Safety Evaluation Report for the
Special Nuclear Material License SNM-986 Renewal Application
Massachusetts Institute of Technology
Cambridge, Massachusetts, 02139

Docket No. 70-0938
CAC L60428

Manuscript Completed: September 2017

Figure 1. Bounding Model Array for SCALE Analysis

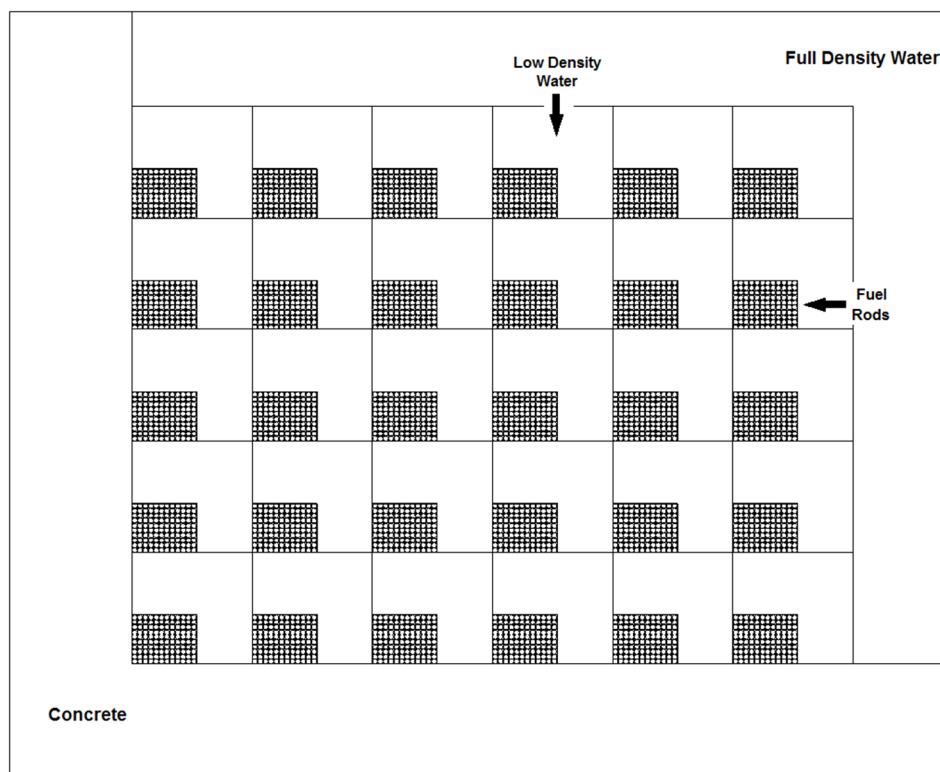
MIT also performed a calculation involving a closely-packed 15×2 array, to simulate the effect of a total structural collapse of the storage rack. This hypothetical scenario is unrealistic and highly conservative considering the tendency of the rods to roll and scatter, rather than remain in a closely packed rectangular array. This model resulted in a calculated k_{eff} of 0.924, which exceeds the license limit of 0.90. However, it would require an inventory substantially greater than that possessed by MIT because it assumed the maximum enrichment of 2 wt% ^{235}U . Based on the modeled enrichment and unrealistic nature of the geometric configuration resulting from a structural collapse of the rack, this is not within the spectrum of credible abnormal conditions that must be demonstrated to be subcritical.

Staff constructed a bounding model using the Standardized Computer Analyses for Licensing Evaluation (SCALE)-6.1 code with the ENDF/B-VII continuous energy cross section library. This provides independent confirmation of the applicant's MCNP5 results. The model, shown below in Figure 1, consisted of a 6×5 fuel box array with the maximum possible fuel rods per storage location. This resulted in a total of fuel rods, which exceeds the actual inventory by a substantial margin. The rods were modeled as UO_2 at full theoretical density, and at the maximum 2 wt% ^{235}U enrichment. The model ignored the rod cladding and instead modeled UO_2 to the outer diameter. The size of the steel frame and wire mesh blocks containing the fuel boxes was reduced from 18 inches to a foot square. Staff performed a parametric study to determine the optimum interspersed water density. As confirmed by the applicant's evaluation, a model in which the pitch between the fuel rods is increased to fill the whole space inside the box is more reactive than a tight-fitting rectangular array. In addition, the more realistic configuration is a triangular-pitched array, which having a smaller void fraction is even more undermoderated than a rectangular-pitched array. Therefore, the optimum-pitch rectangular array is very conservative. With these conservative assumptions including total fuel inventory, enrichment, rod pitch, and array spacing, the maximum calculated k_{eff} was approximately 0.89. While this is just below the regulatory limit of 0.9, it demonstrates a substantial margin of subcriticality. Staff considers the addition of extra rods in each storage location and reduced spacing between fuel boxes to bound credible spacing upsets or the addition of extraneous material to the storage array. Therefore the staff finds the applicant's commitments to criticality evaluation to be adequate.
